Pre-review of mechanical designs for the MPPC-PCB & LGP module toward mass production

7 December 2020

Tsunayuki Matsubara (KEK)

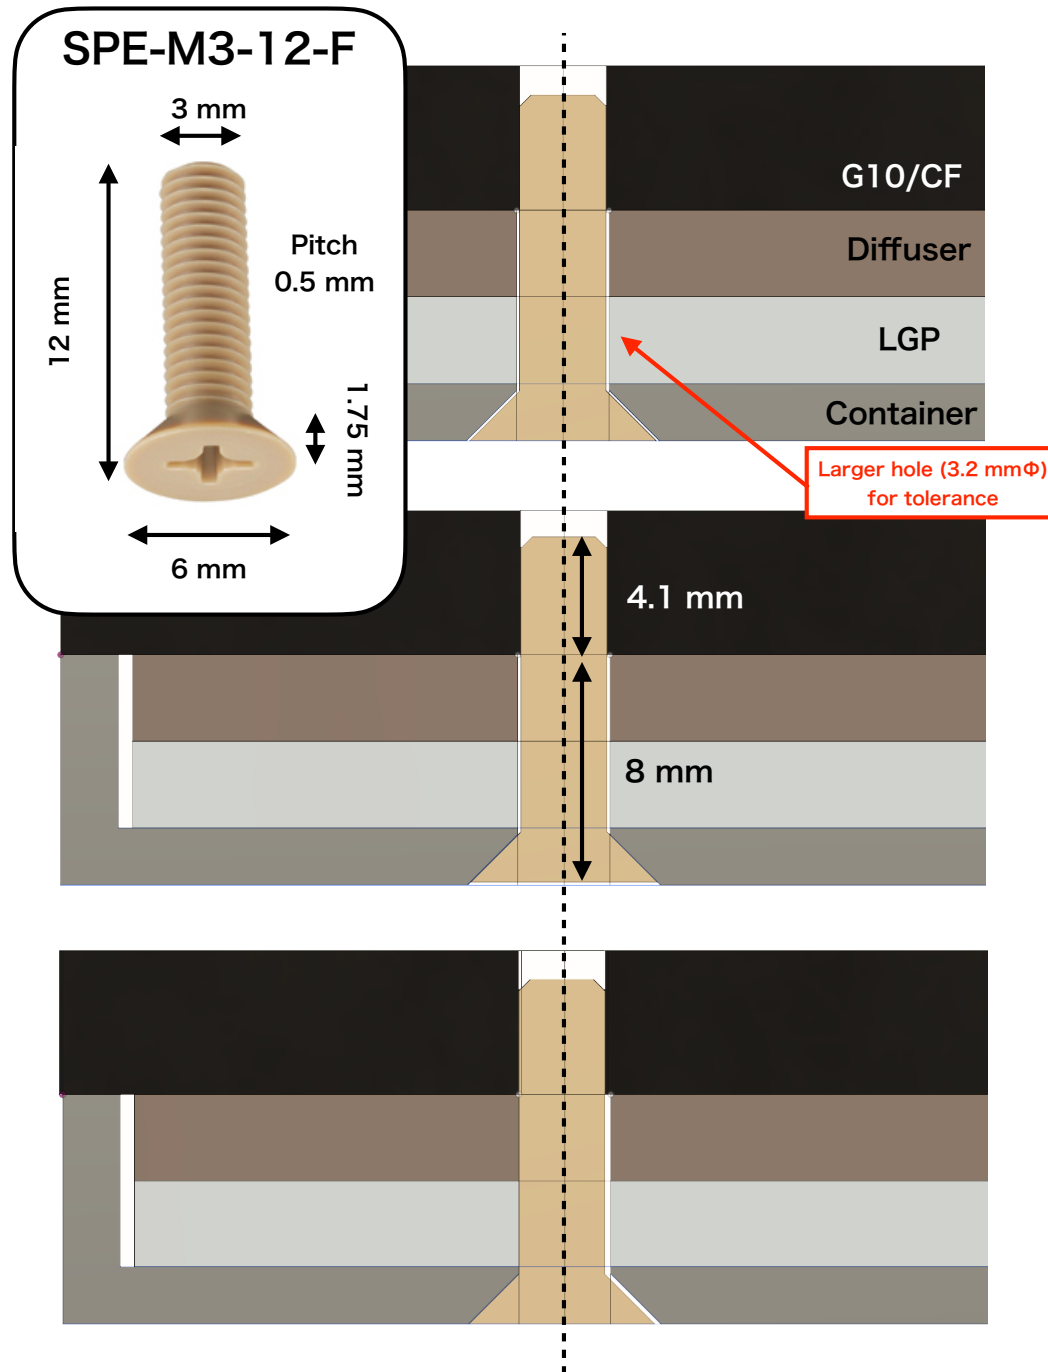
We only need a cross-section of “8 mm x 3 mm” for cable routing around the detector

Drawing of the wall module

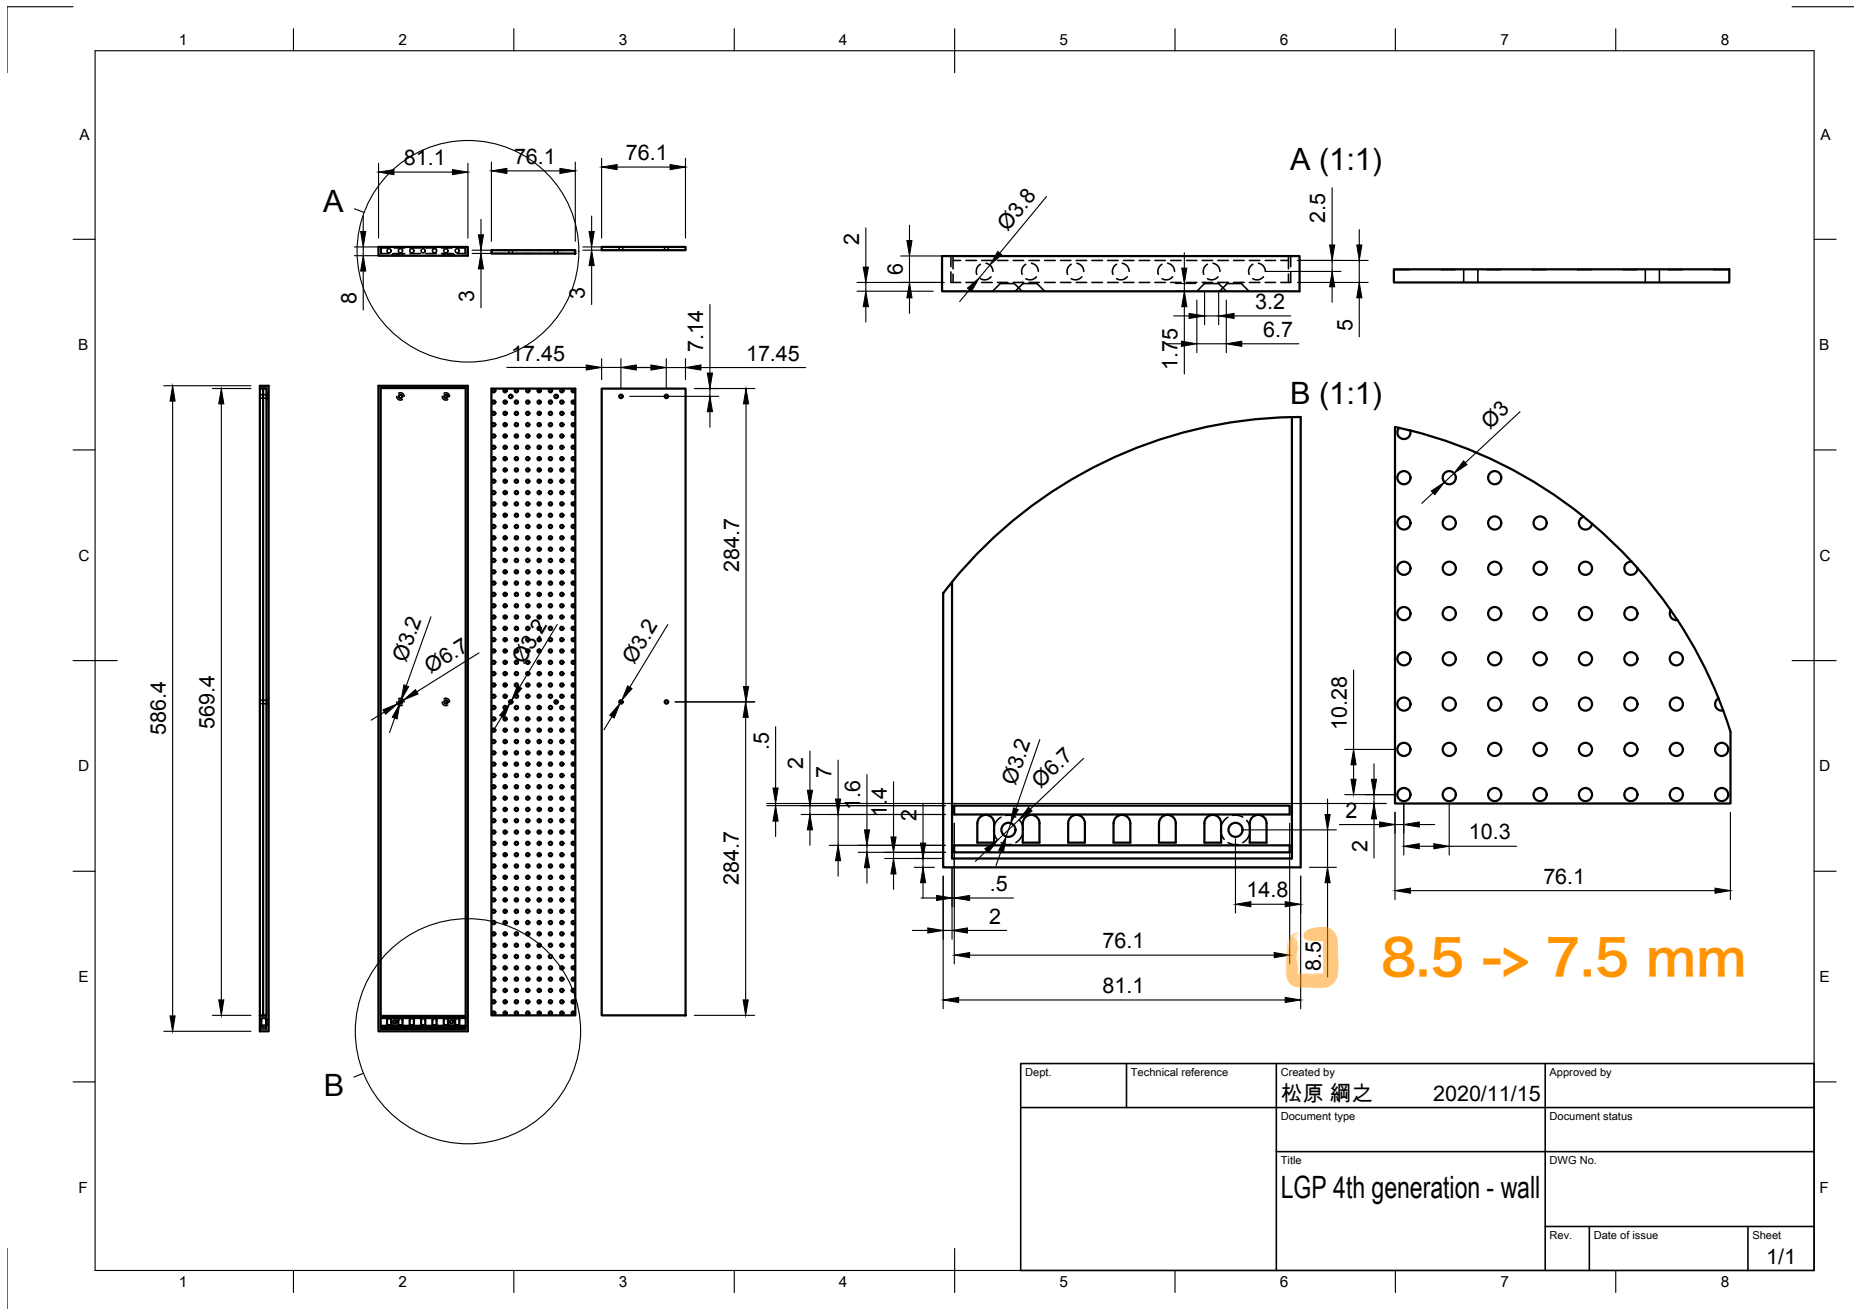
- Current G10 for the calib. system is 4 mm.
- **Additional depth of 0.1 mm at least is needed in the CF layer for screwing.**

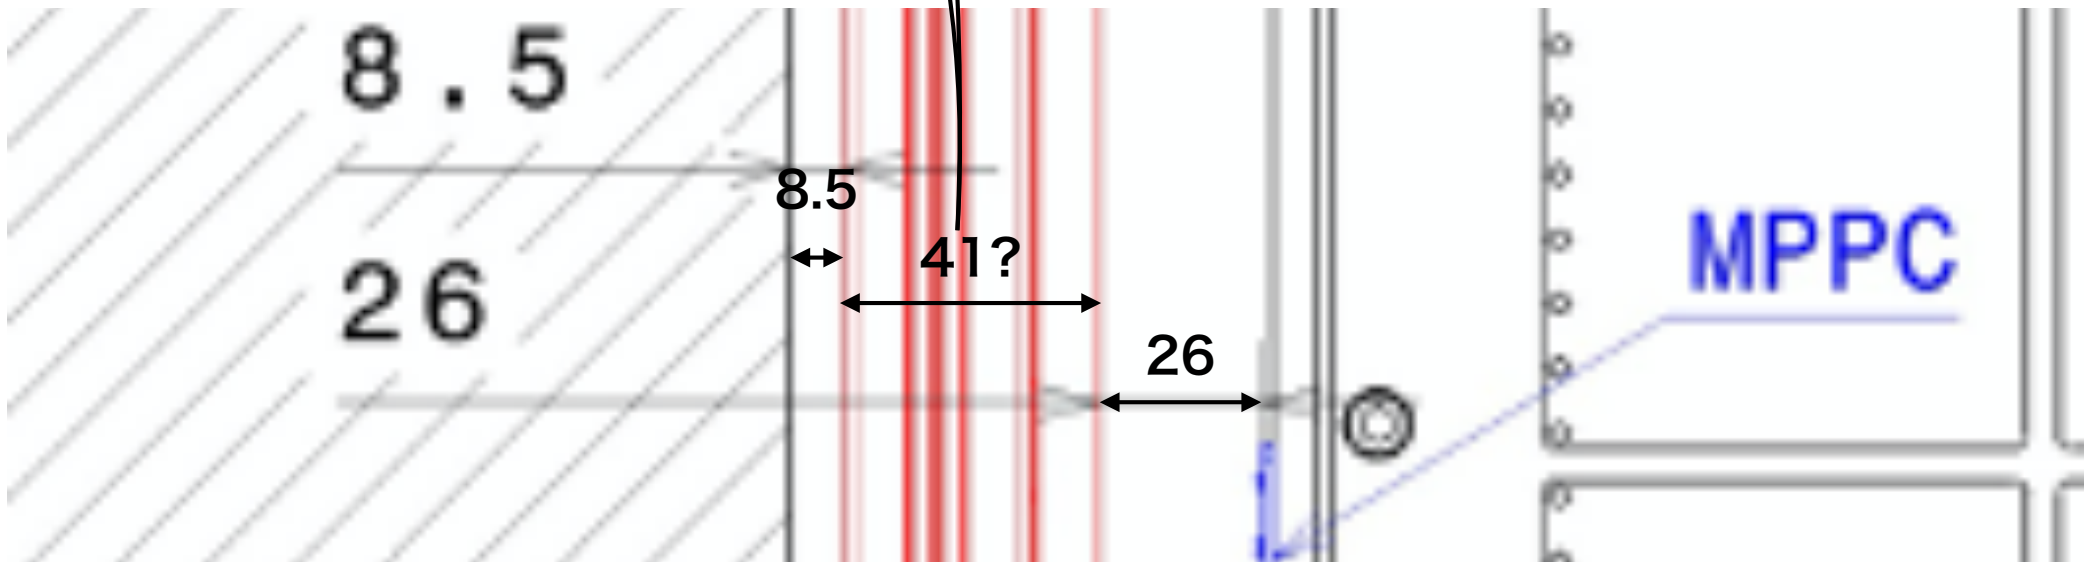
- TOF thickness for envelope (41 mm) is obtained by eye from this drawing.
- Need to check with the model
